INDESIT company

Model type:
ARXD109EU

Commercial code:
F052858

1140150C Exploded views

1230330B Exploded views

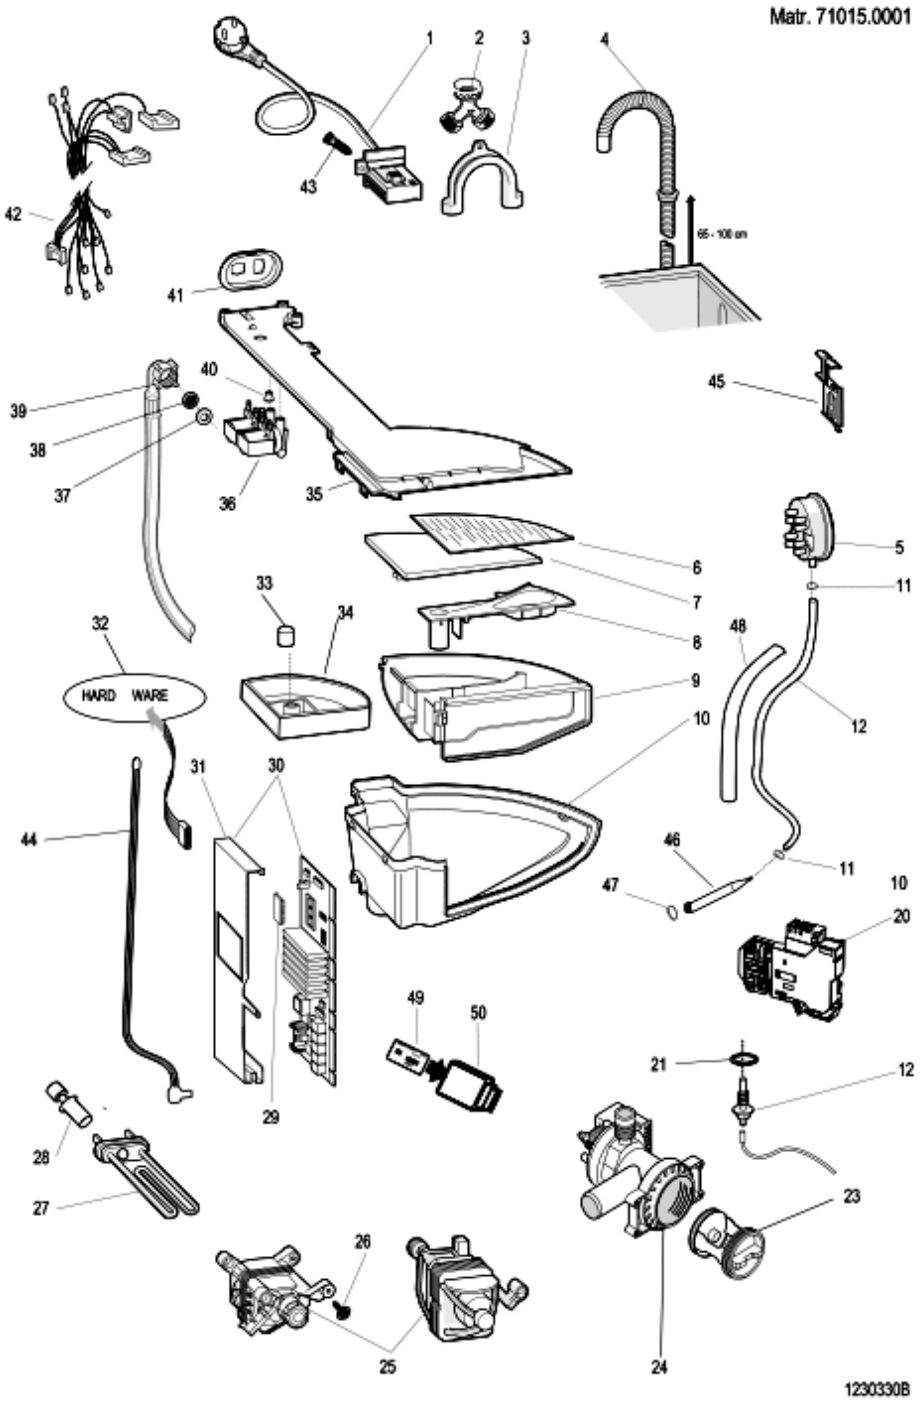
n4008f00: Thermic link wire removed on three-phase motor

Attention!

When you assist the premodification models using the new motor code you MUST use the thermic link wire code C00265838.

The spare part warehouses will manage the premodification motor until the end of the stock, after they will be replaced with new ones and thermic link wire.

TRIPHASE P40 46 L – PLASTIC TUB
C00265826 new motor without thermic link wire - C00142390 premodification motor with thermic link wire
